**Pacific Gas and
Electric Company**

PG&E Letter DCL-03-113

Docket No. 50-275, OL-DPR-80
Diablo Canyon Unit 1
PG&E Response to NRC Questions on 1R11 Steam Generator Tube Inspections

PG&E Response to NRC Questions on 1R11 Steam Generator Tube Inspections

Figure 1

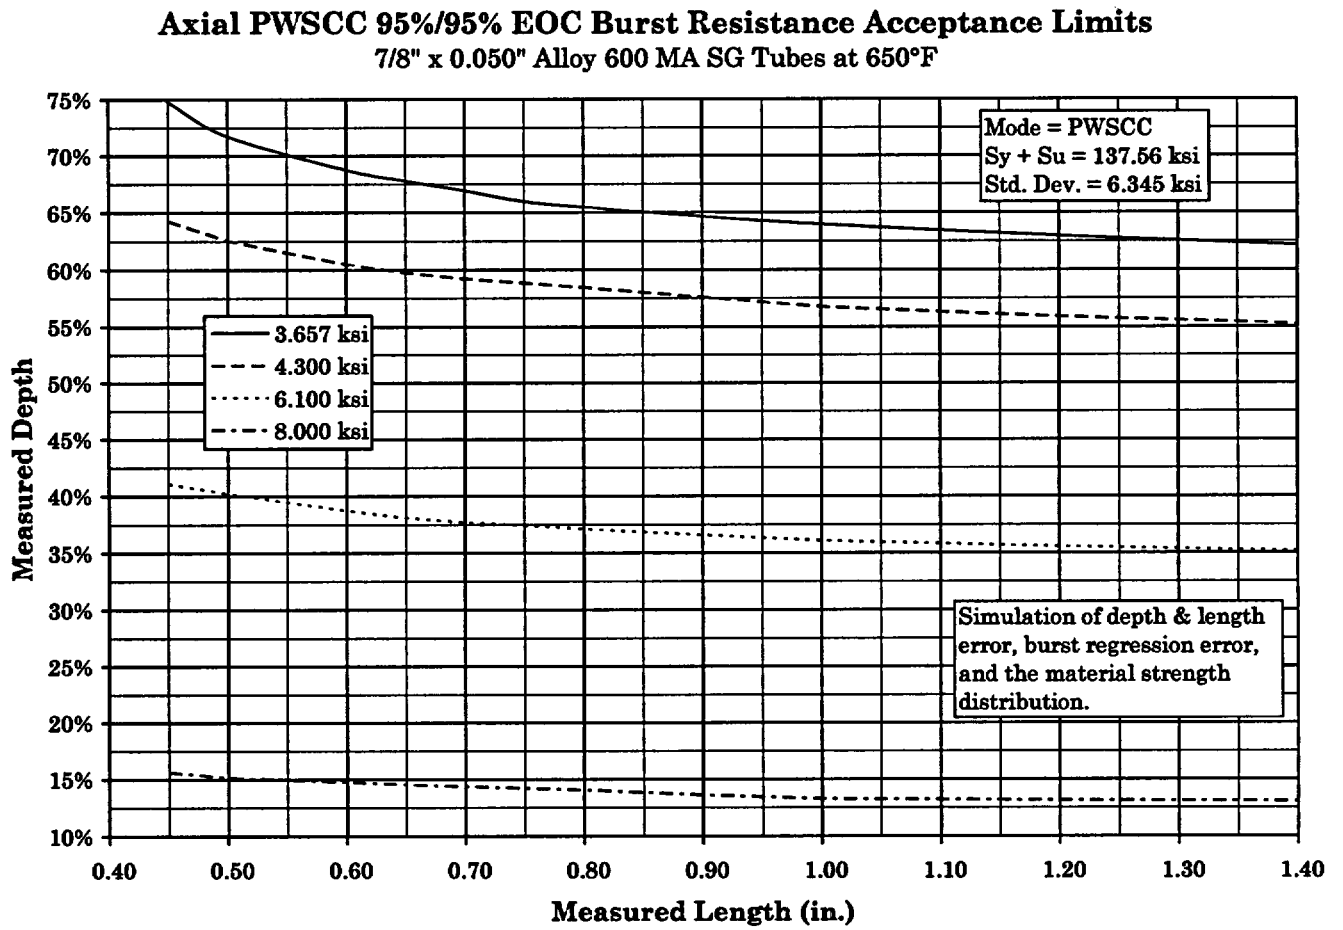
"An evaluation was provided regarding the ability of the operational assessment methodology to predict flaw distributions as a function of flaw size. This evaluation focused on the predicted burst pressure of the specimens. Whereas the burst pressure gives insights on the severity of the degradation, it does not directly verify whether the methodology for predicting the length and depth of the degradation provides conservative results (i.e., the predicted burst pressure may be accurate but for the wrong reasons). In addition, given that the computer code for predicting the burst pressure only provides an actual estimate of the burst pressure when it is less than some cutoff value (e.g., 6100 psi), it would not provide information that would indicate whether under predictions of the burst pressure were being made (unless most burst pressures were less than this cutoff value). That is, suppose the predicted burst pressure for EOC 12 was 9000 psi, the computer code would only indicate that it was greater than 6100 psi. If in this case, the actual burst pressure was determined at the EOC 12 to be 6500 psi, the methodology would have under predicted the burst pressure by 2500 psi. Whereas this specific example does not pose a safety issue, it may provide an early indication that the methodology is not providing conservative results. Please discuss your plans to address these issues in future assessments."

As previously discussed with the NRC in PG&E letter DCL-02-045, "Response to Final NRC Request for Additional Information Regarding Supplement 3 to License Amendment Request 00-06, 'Alternate Repair Criteria for Axial PWSCC at Dented Intersections in Steam Generator Tubing,'" dated April 18, 2002, the distribution of burst pressures above 6100 psi is not considered to be important for tube integrity assessments. In addition, differences between projected and as found burst pressures where both burst pressures are greater than 6100 psi are not recommended for assessments of the adequacy of the methodology. The flaw sizes at the beginning of the cycle being projected are very small where nondestructive examination (NDE) uncertainties are large and differences between projections and as found burst pressures can be significant with no implications on the adequacy for tube integrity analyses. Figure 1 plots average depth versus length requirements (at the 95/95 confidence levels used for burst analyses) to satisfy burst pressures of 8000, 6100, 4300 (near $3\Delta P_{NO}$) and 3657 ($1.4\Delta P_{SLB}$) psi. To satisfy burst pressures of 6100 psi and 8000 psi, the average depths must be less than about 35 percent to 42 percent and 16 percent, respectively, or less than a length of 0.45 inch for which even a throughwall indication satisfies burst margin requirements. If the indication is projected to have an average depth less than 40 percent such that the projected burst

pressure is greater than 6100 psi, and the as found indication has an average depth less than 40 percent to satisfy a burst pressure greater than 6100 psi, the methodology is considered to be very adequate even if the burst pressures might differ by 1000 psi above 6100 psi. Since the axial PWSCC sizing methods require the maximum depth to be at least 20 percent, predictions of burst pressures less than 8000 psi are essentially forced by the sizing methods. Consequently, there is no need to assess differences in burst pressures above 6100 psi and there is no need to revise the computer code to edit the high burst pressures.

Assessing the adequacy of the operational assessment methods based on burst pressure comparisons is considered to be more relevant and significant than separate comparisons of lengths and depths. Typically, when lengths are underestimated, the flaw has shallow tails that are not detected and the sizing would be expected to reflect a larger average depth over the detected length than would be obtained for the total length. If a length and/or depth was different between the projections and as found, the significance of the difference would have to be assessed by comparing the burst pressures. The sizing methods are considered to predict conservative results only if the burst pressure is conservatively predicted.

In summary, the current comparisons of projections and as found based on burst pressures less than 6100 psi and on SLB leak rates are considered to be the most appropriate and meaningful methods for evaluating the methodology. It is planned to continue these comparisons for future assessments.

**Figure 2. Flaw and Mix Residual (400/100 Mix) for Plant A-1 Pulled Tube
R27C54-1H**

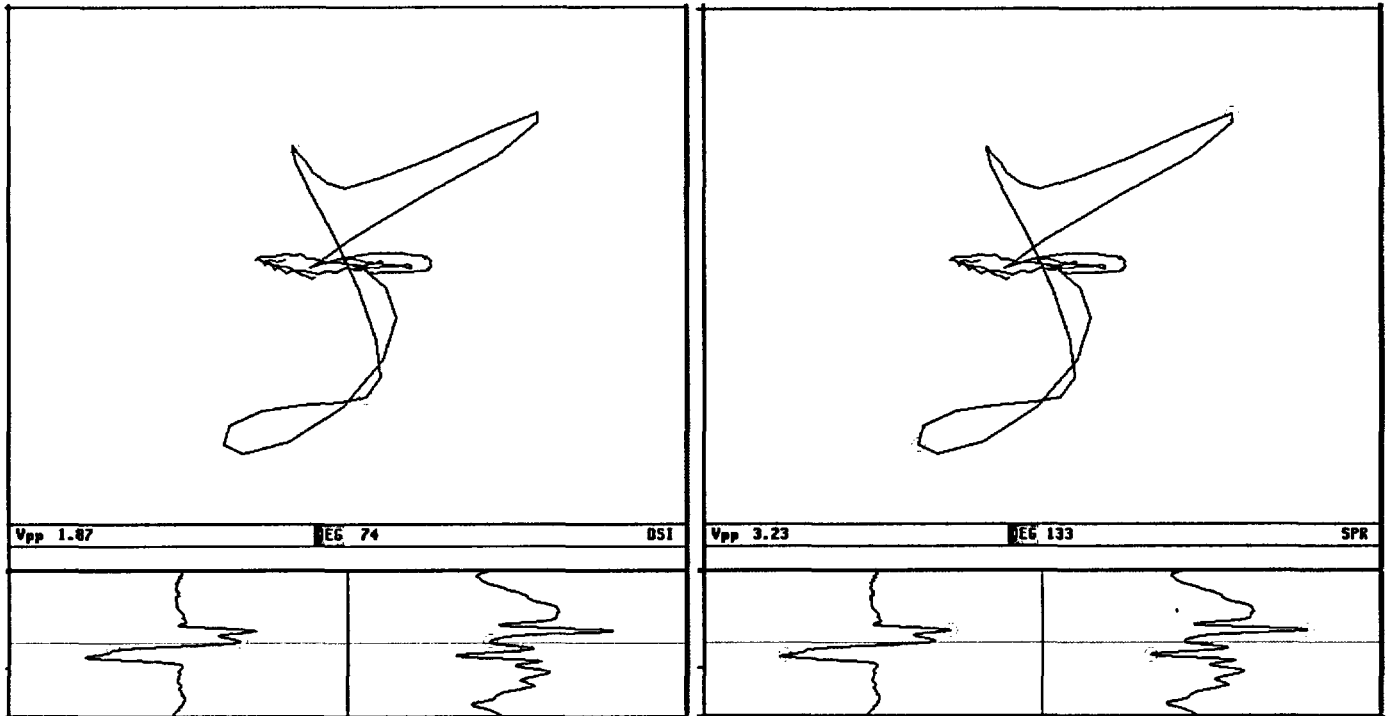
“What is the basis for the 1 volt limit for support plate residual (SPR) indications? Discuss whether the voltage readings for indications located at SPR intersections are consistent with the voltage readings that would be obtained from the same indication if there was no support plate residual influence.

With regard to the presence of mix residuals and the influence of the mix residuals on sizing the indications, it must be emphasized that all TSP intersections have mix residuals after the first one or two cycles of operation. After about two cycles, the mix residuals generally do not change with operating time. The dominant voltage for the mix residual signals is not affected by the mixing used to analyze the bobbin data so the mix residual signal amplitude does not vary with operating time or NDE analyst. Frequently, a significant part of the mix residual signal is present in bobbin data obtained without a TSP for pulled tubes examined in the laboratory. Some of the model boiler specimens show mix residuals although generally smaller than field data due to the shorter time at temperature. The bobbin response apparently includes an effect of the time at temperature at a TSP on the magnetic properties of the tube. Metallography was performed on a pulled tube to attempt to identify the cause for the signal, but was not successful in identifying any physical change to the tube or grain structure.

Many of the pulled tubes in the ARC database (and the prior cycle probability of detection or POPCD database) have mix residual signals larger than typically found in currently operating SGs. Figure 2 shows the 1.87 flaw voltage and the 3.23 mix residual voltage for pulled tube R27C54 from plant A-1 in the ARC database. This is only one example of the pulled tube data. Whatever influence the mix residuals may have on voltage sizing for TSP indications is built into the ARC database by the pulled tubes. The mix residuals may be more easily understood as TSP noise. The noise may distort the flaw signal particularly when the two-phase responses are similar.
